## **Packet Guide**

BAR 21-07-01

854 Locust Avenue, Tax Parcel 510092000

Project: Garage construction

THE CONTRACTOR SHALL FIELD VERIFY ALL DIMENSIONS AT THE SITE & NOTIFY THE ENGINEER IN WRITING OF ANY DISCREPANCIES.  
 Drawn By: TJW  
 Checked By: ATG  
 Scale: As indicated  
 Date: 11/14/2016  
 File No: 2015-016  
 Sheet No: **A-200**  
 FOR CONSTRUCTION

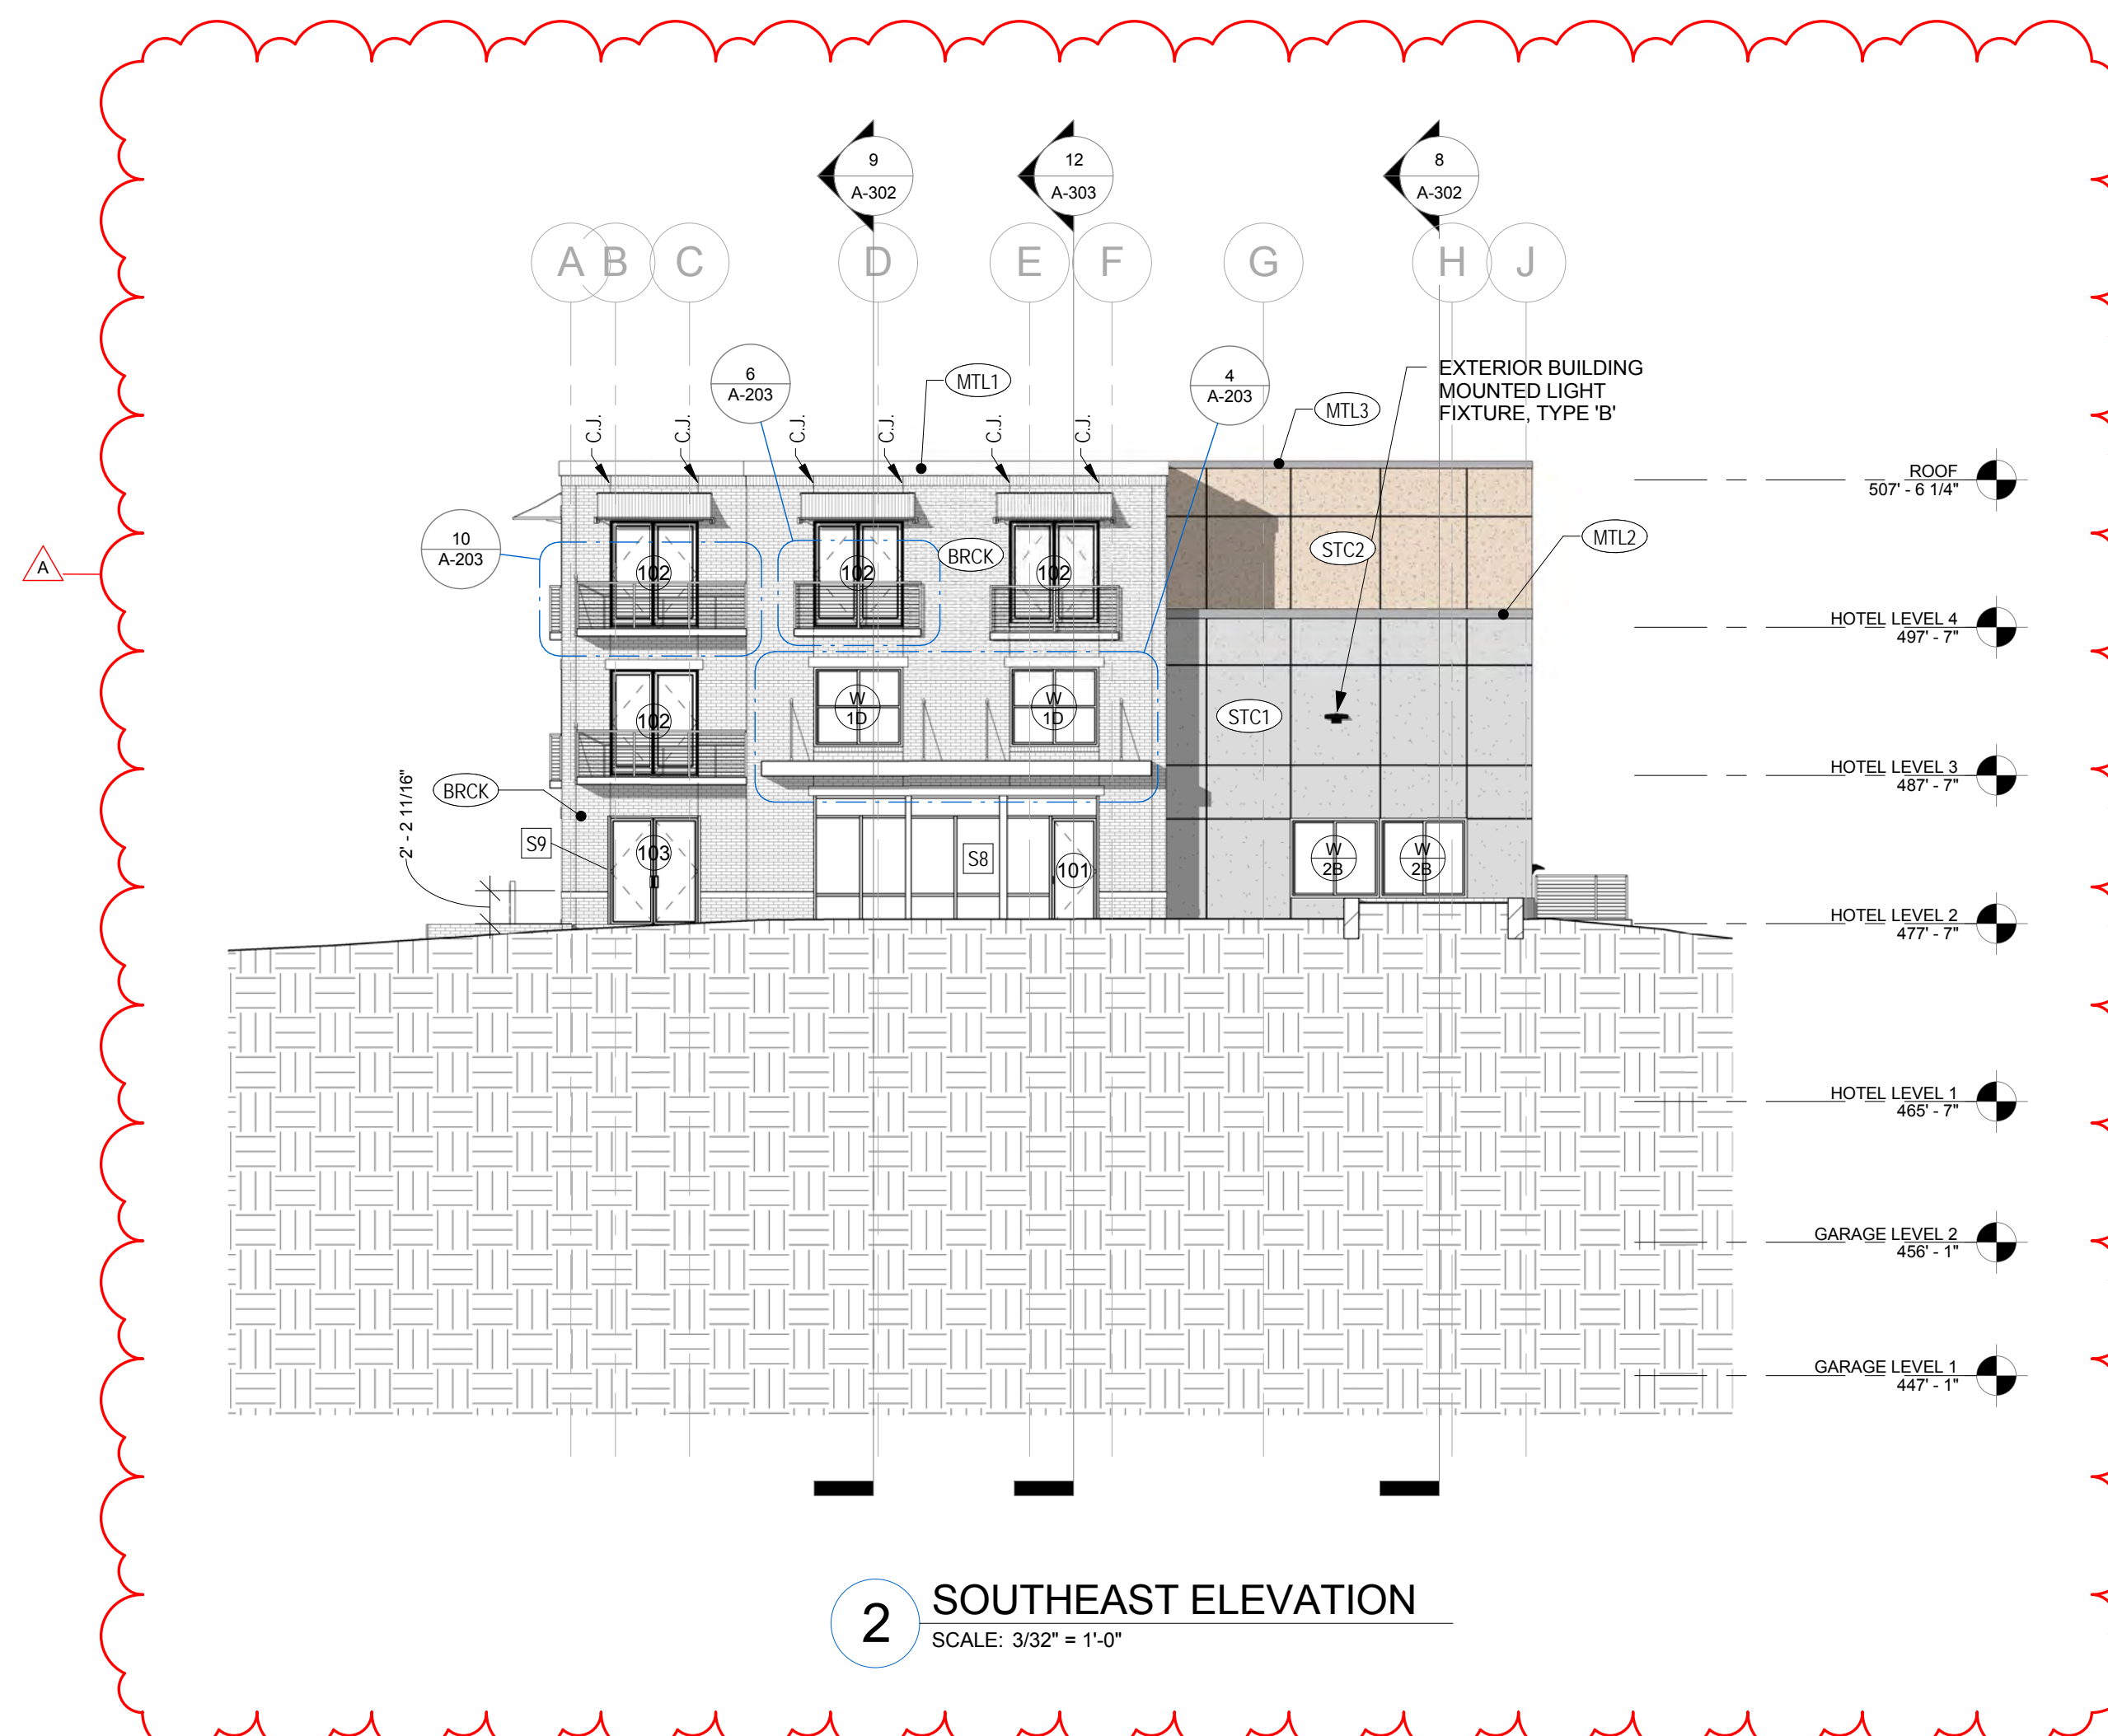
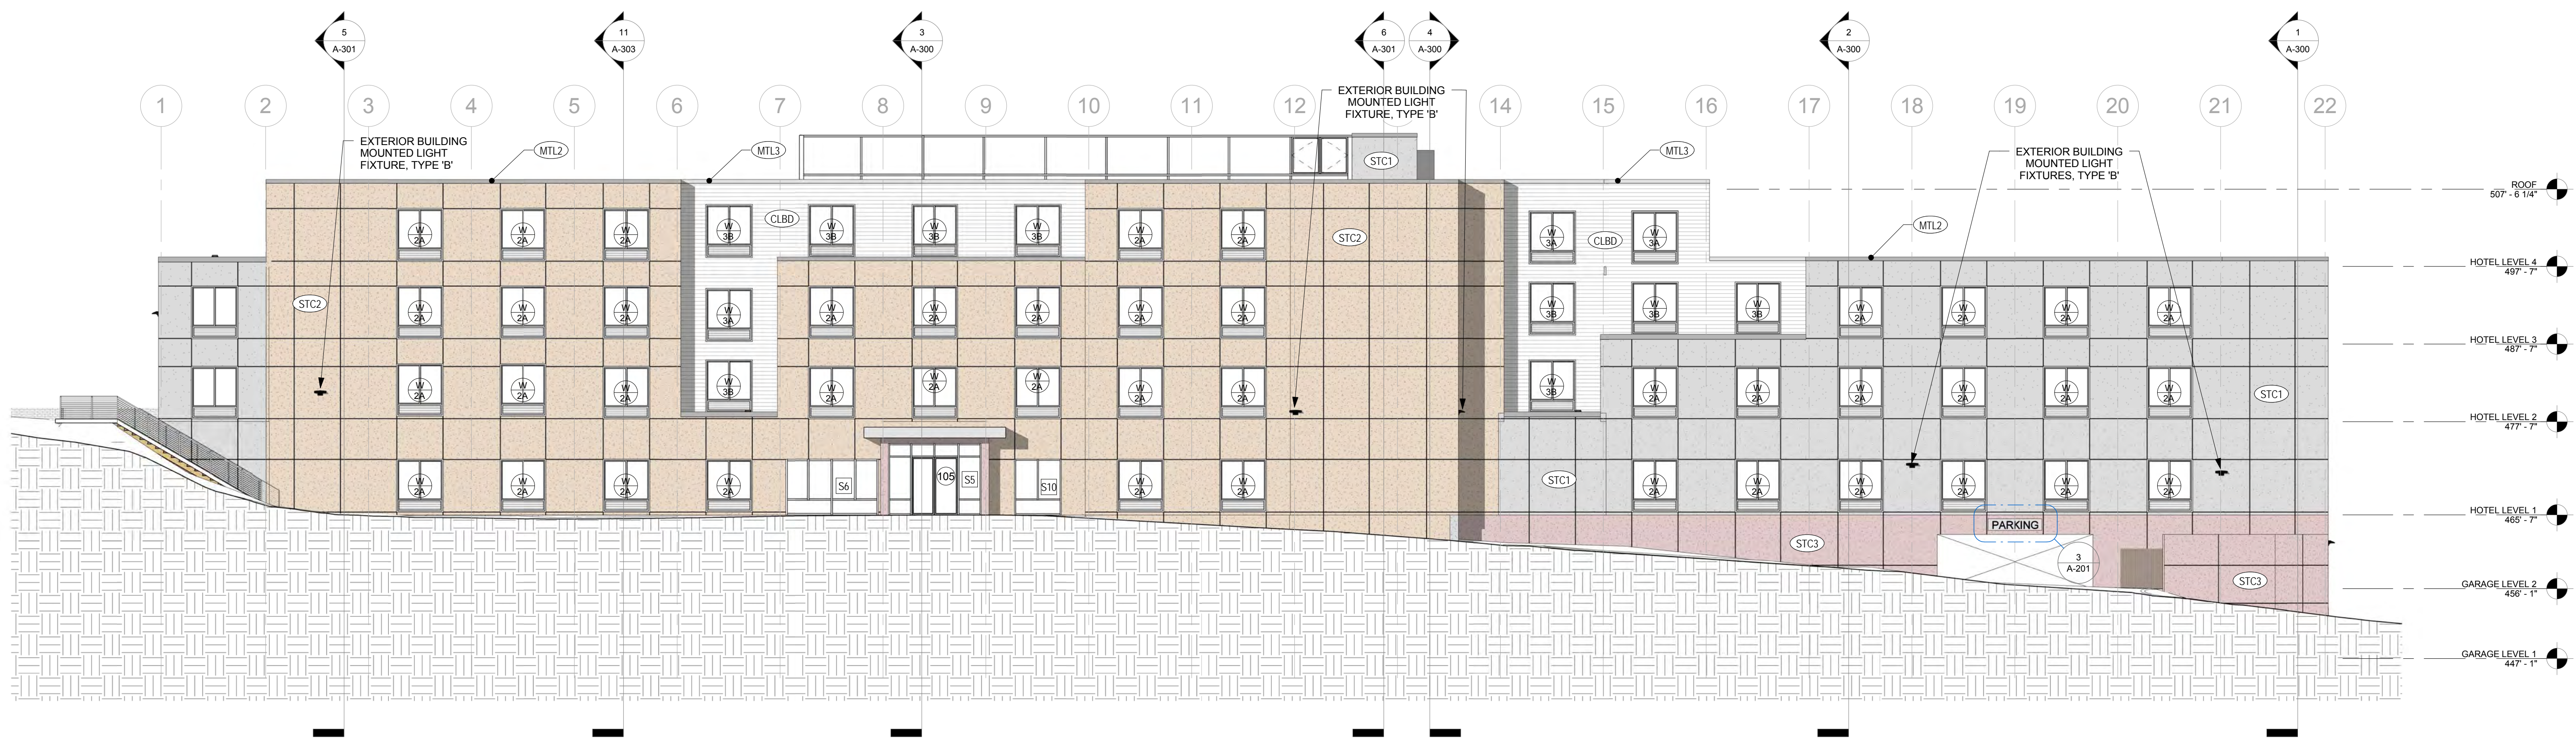
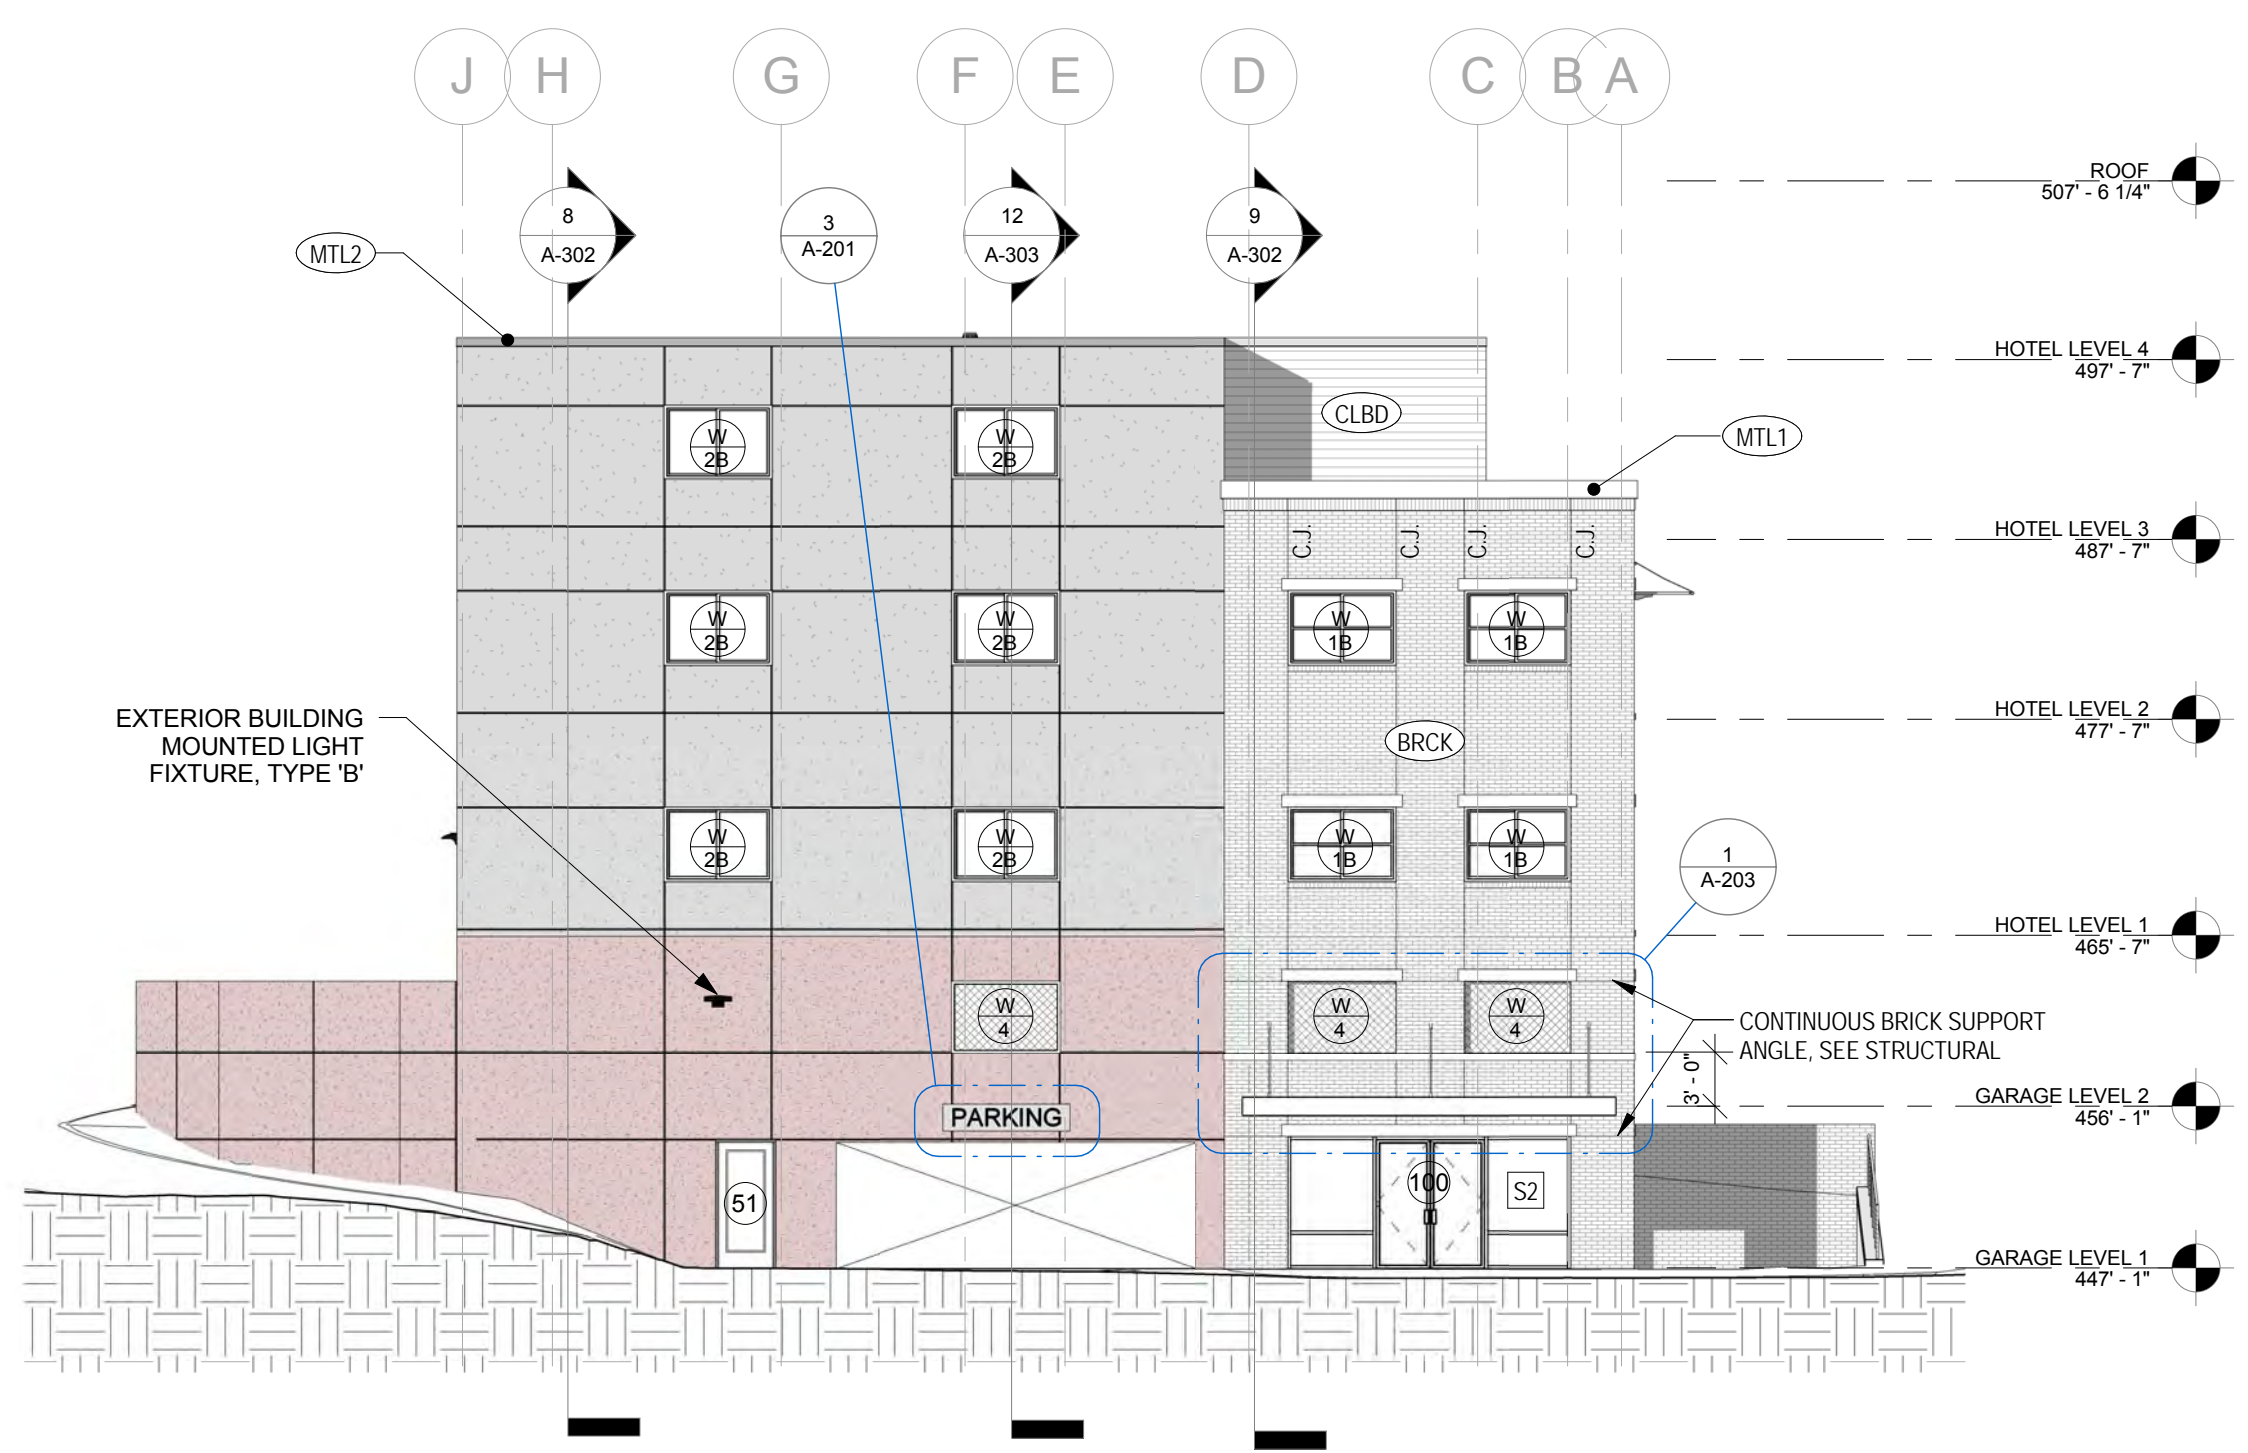
The areas to be repaired are all stucco walls shown on the elevations on sheets A-200 and A-201-- see the key in the lower, righthand corner. (Note: the clouded area on these sheets are not relevant. They are from modifications made in 2017, and not related to the stucco repair.)
